ADDENDUM NO. 01

RANKIN TRAILS AMPHITHEATER AND BASEBALL PARK

Rankin County, Mississippi

WBA Proj. # 2215/2315

S2.4
STAGE ROOF FRAMING
PLAN

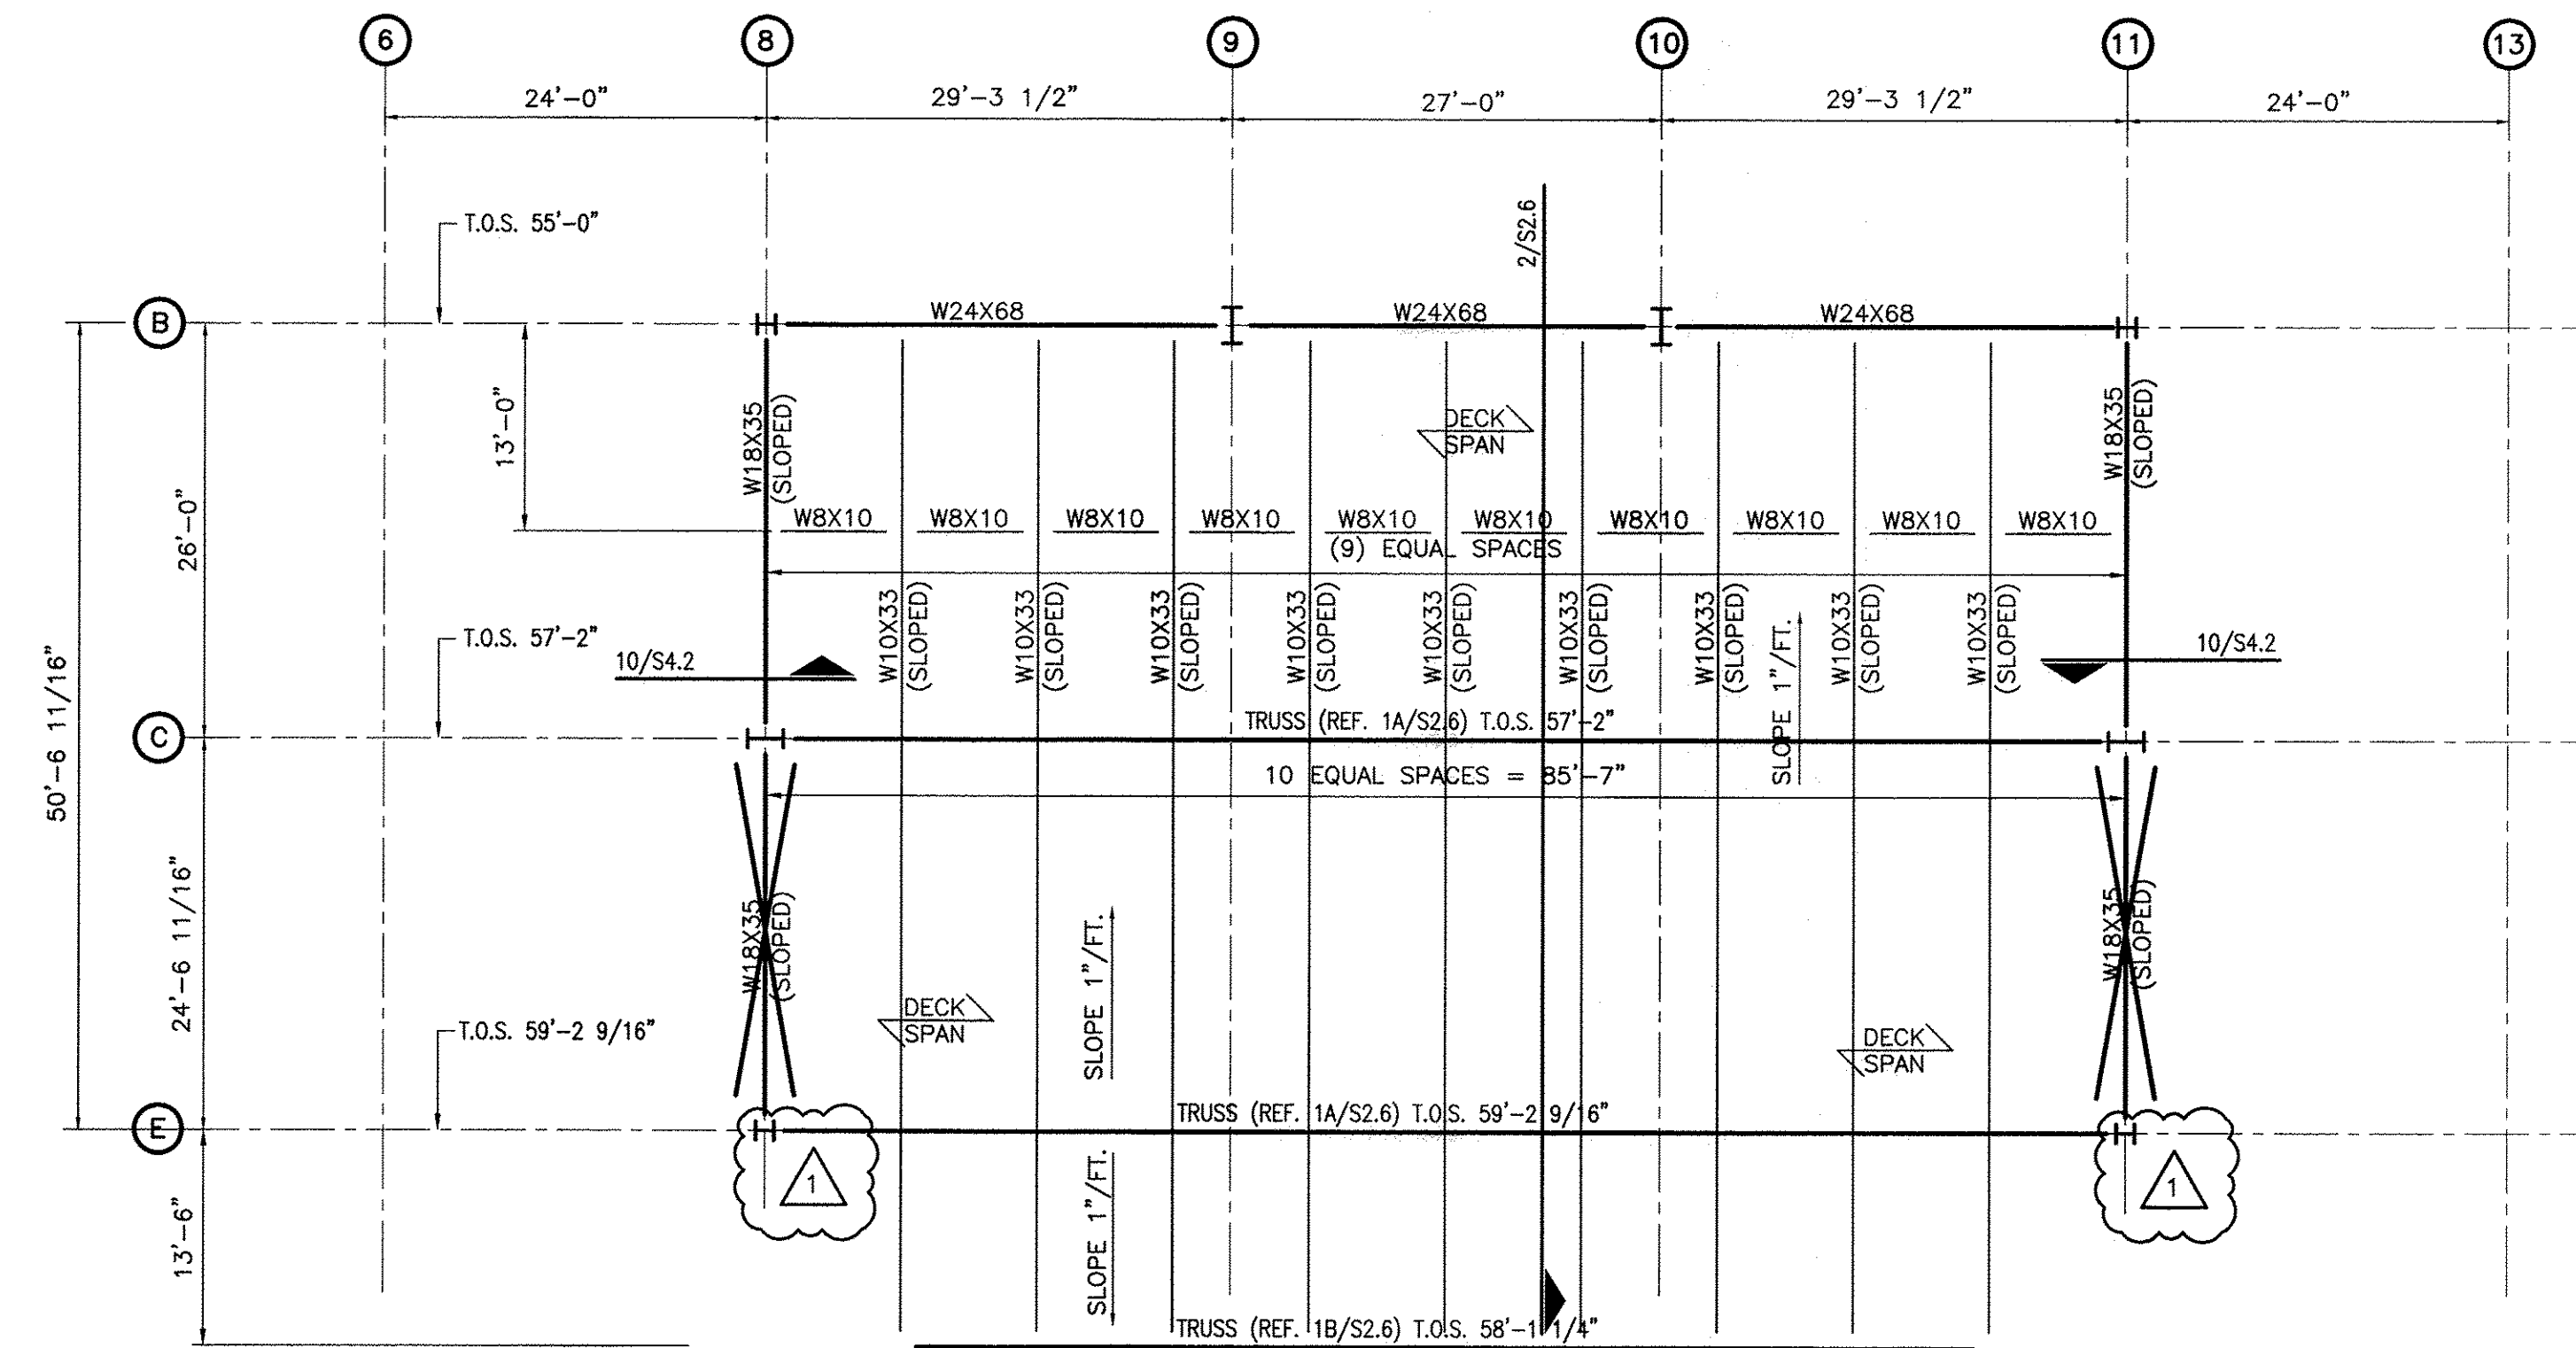
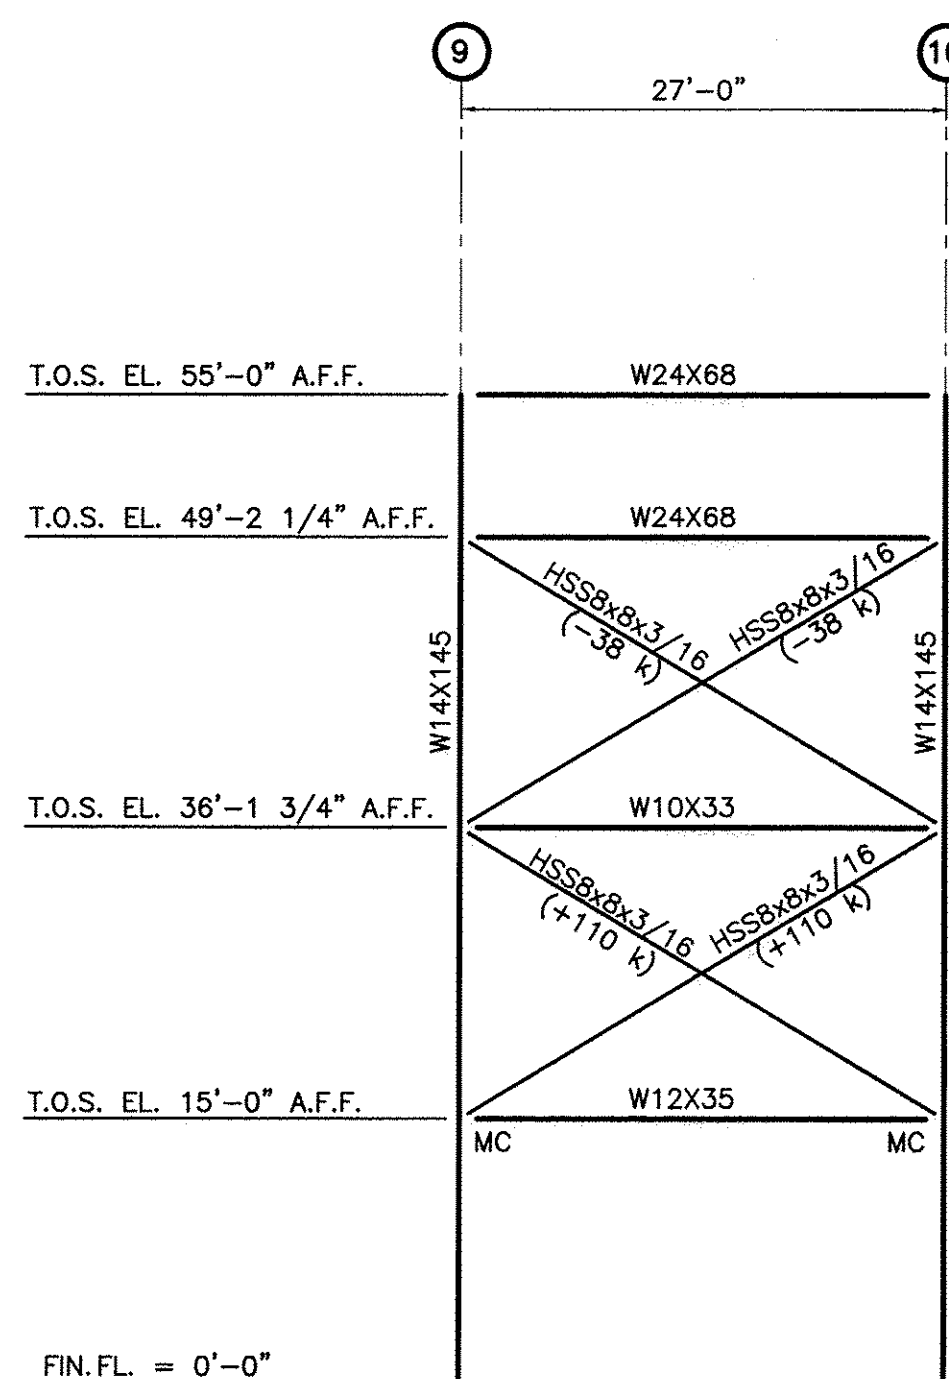
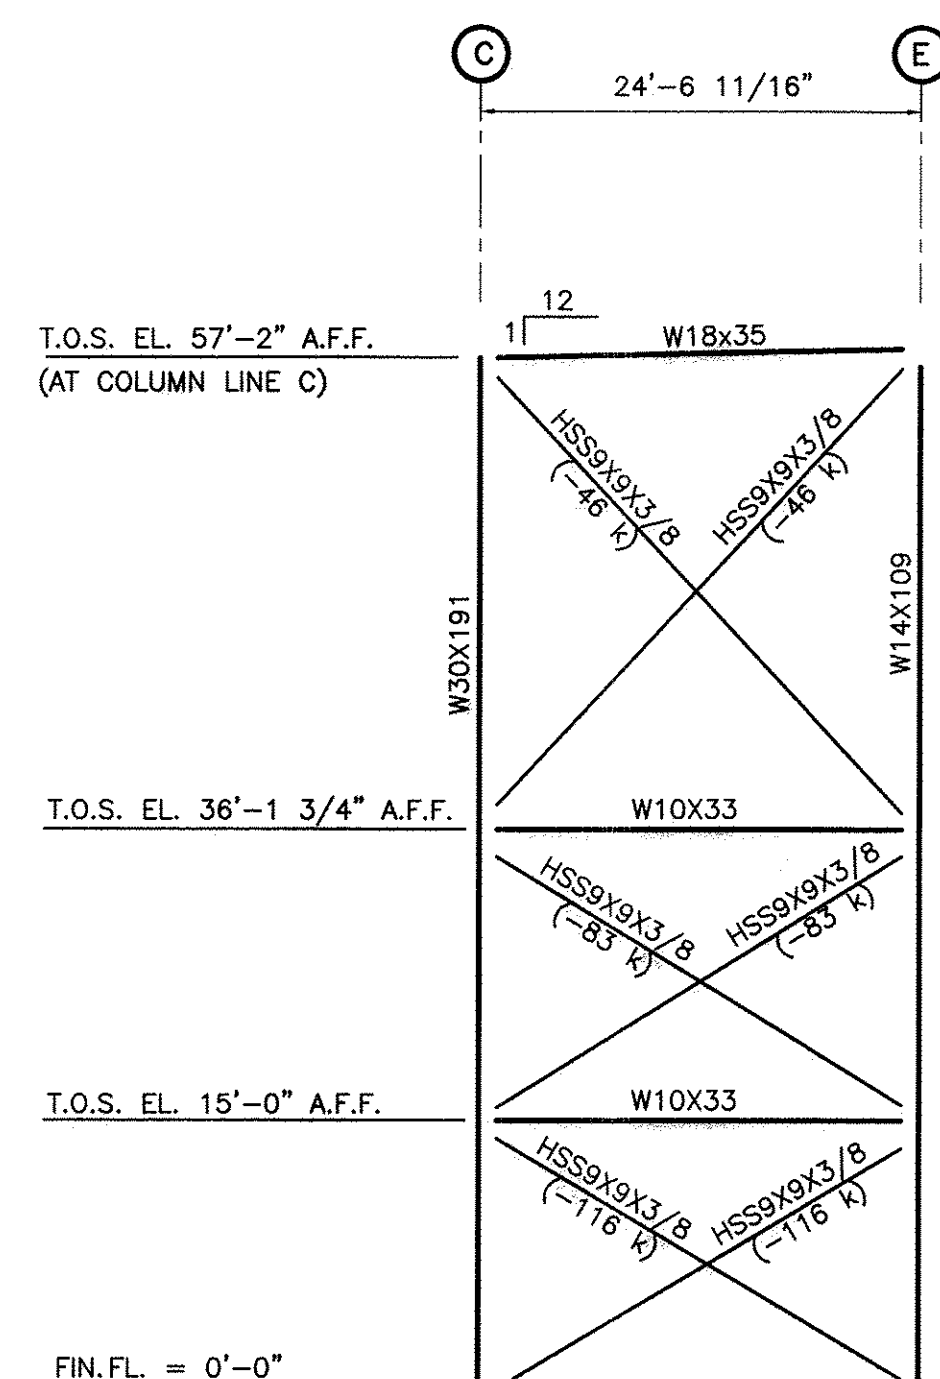
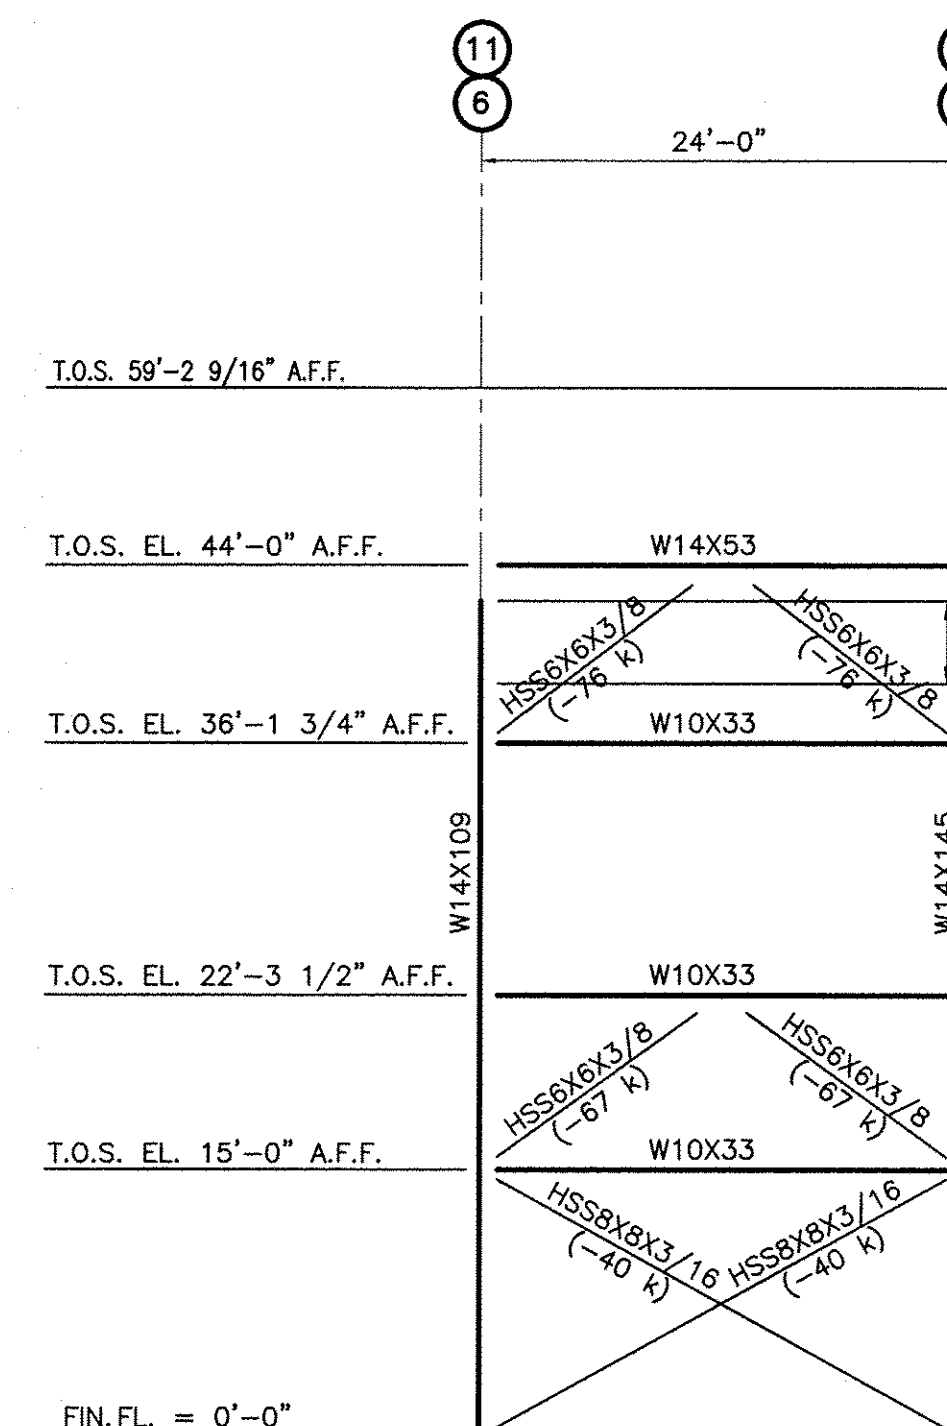
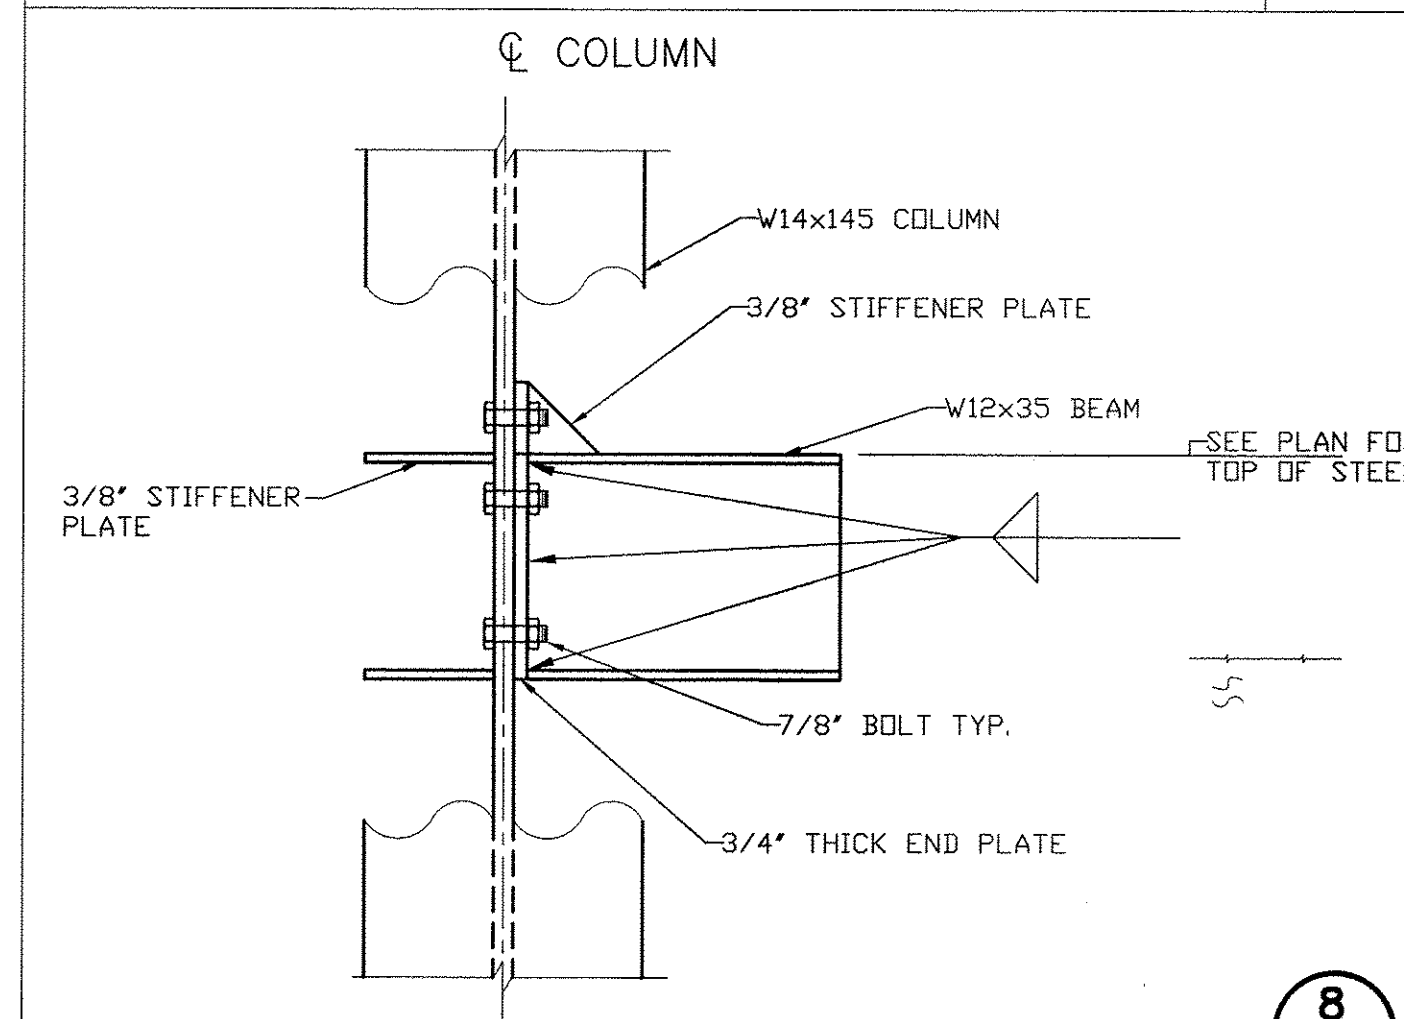
- ITEM NO. 14** **SHEET S2.4 STAGE ROOF FRAMING PLAN**
REVISE column rotations to match foundation plan, per enclosed revised sheet S2.4.
REVISE column base plate, per enclosed revised sheet S2.4.
